## Addendum

Iowa Department of Transportation Date of Letting: December 15, 2015

B.O.	Proposal ID	Proposal Work Type	County	Project Number	Addendum
110	52-5557-619	PCC PAVEMENT - WIDENING	JOHNSON	STP-A-5557(619)86-52	15DEC110.A03

Replace plan sheet MW.02 with the attached:

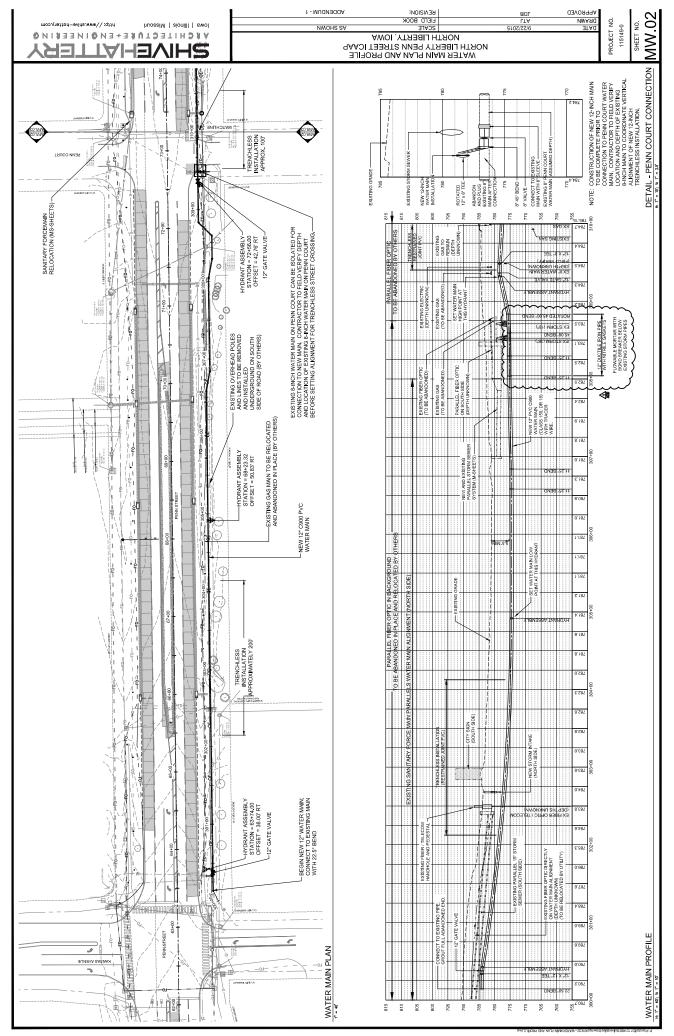
REFER TO SHEET MW.02. PIPE IS REQUIRED TO HAVE NITRILE GASKETS. WORK INCLUDES PROTECTION AND SUPPORT OF EXISTING STORM SEWER CROSSINGS, AND PLACEMENT OF FLOWABLE MORTAR AND BOND BREAKERS AT THE CROSSING LOCATIONS.
